### RESPONSE TO COMMENTS - TENTATIVE WASTE DISCHARGE REQUIREMENTS FOR SHELDON-ARLETA LANDFILL, LOS ANGELES, CALIFORNIA (File No. 60-100, CI 2765, Geotracker Global ID L10008273857)

**WASTE DISCHARGE REQUIREMENTS  
for  
CITY OF LOS ANGELES, BUREAU OF SANITATION  
(Sheldon Arleta Landfill)**

**RESPONSE TO COMMENTS**

**POSTCLOSURE MAINTENANCE  
WASTE DISCHARGE REQUIREMENTS  
FOR  
CITY OF LOS ANGELES  
(Sheldon-Arleta Landfill)**

Figure 1. Groundwater Well and Leachate Well Locations

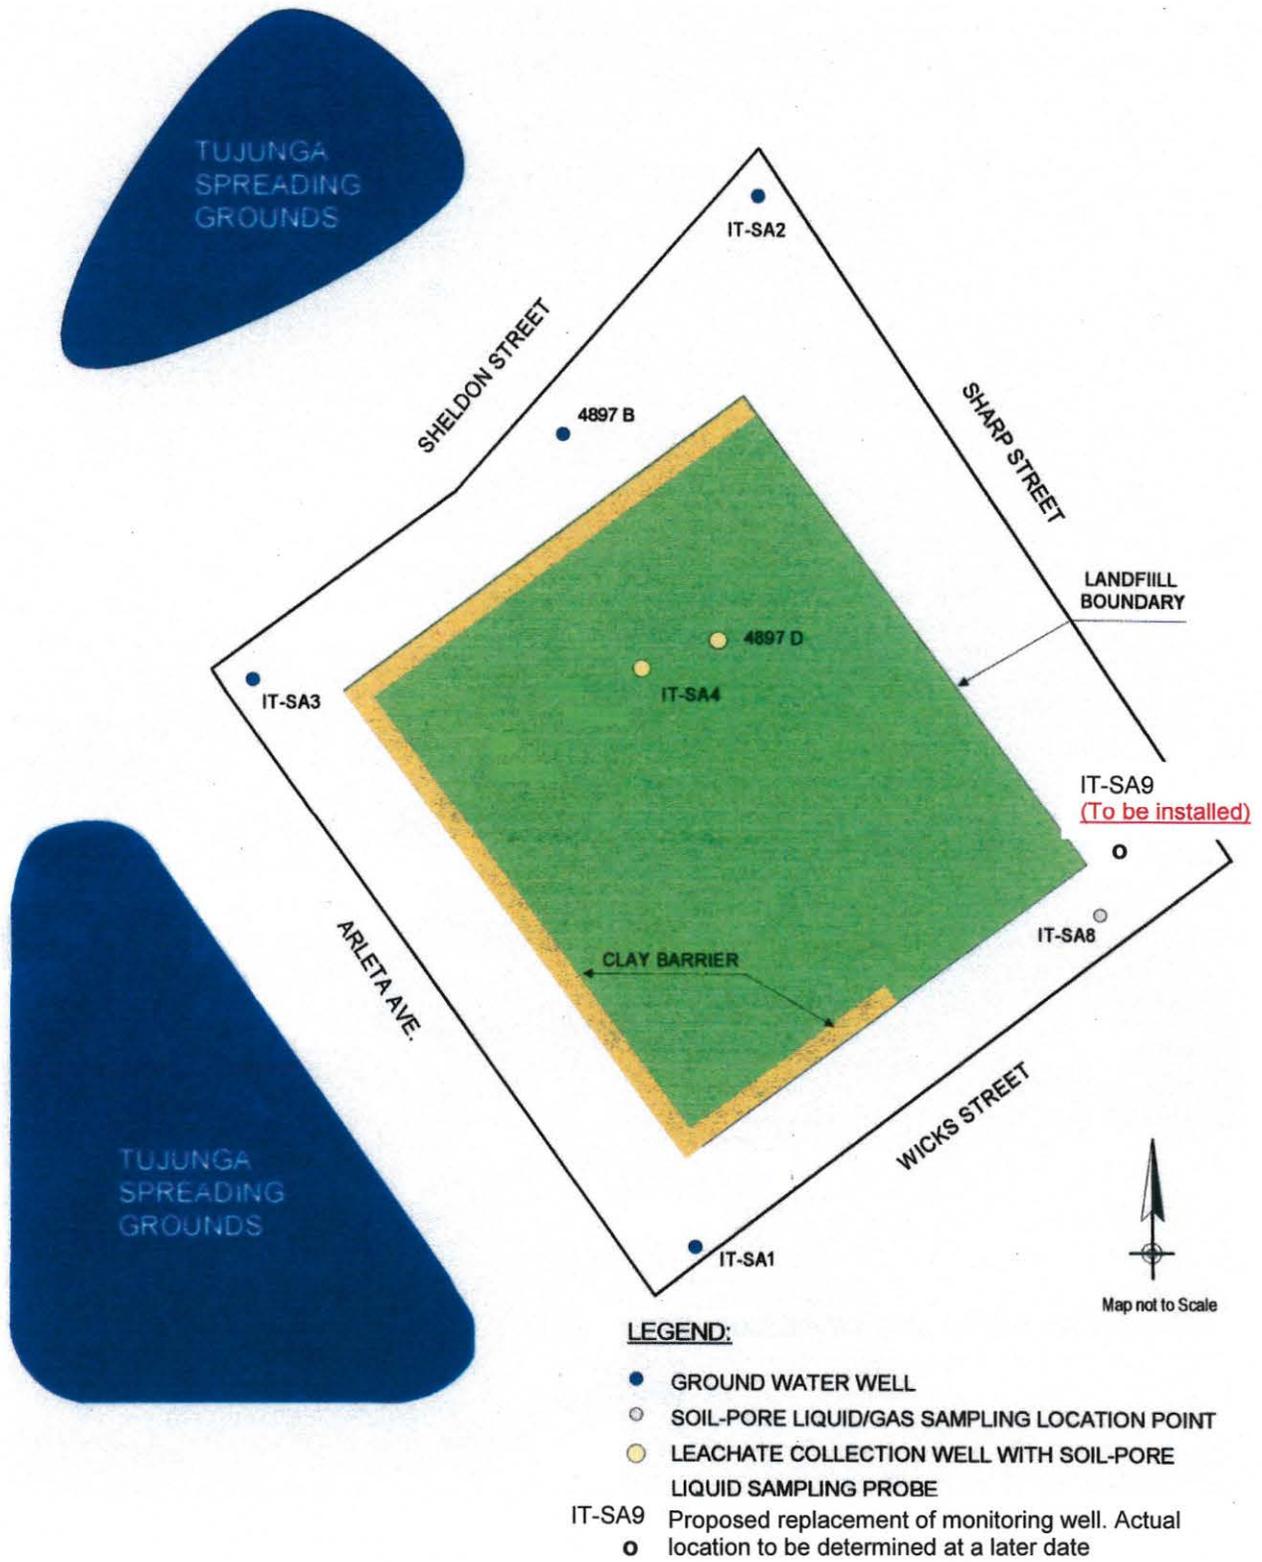
*[Page 20, map] Label IT-SA3 BACKGROUND, IT-SA1 & IT-SA9 Monitoring. Put new well [call it IT-SA9] just outside the landfill [green square] vertex.*

1. [Page 20, map] Label IT-SA3 BACKGROUND, IT-SA1 & IT-SA9 MONITORING. Put new well [call it IT-SA9] just outside the landfill [green square] vertex.

**Response:** Staff agrees with the comment. Figure 5 of the WDRs and Figure 1 of the MRP has been changed to reflect the proposed well IT-SA9. Table T-1 of the MRP, Section II.A, has been modified accordingly.
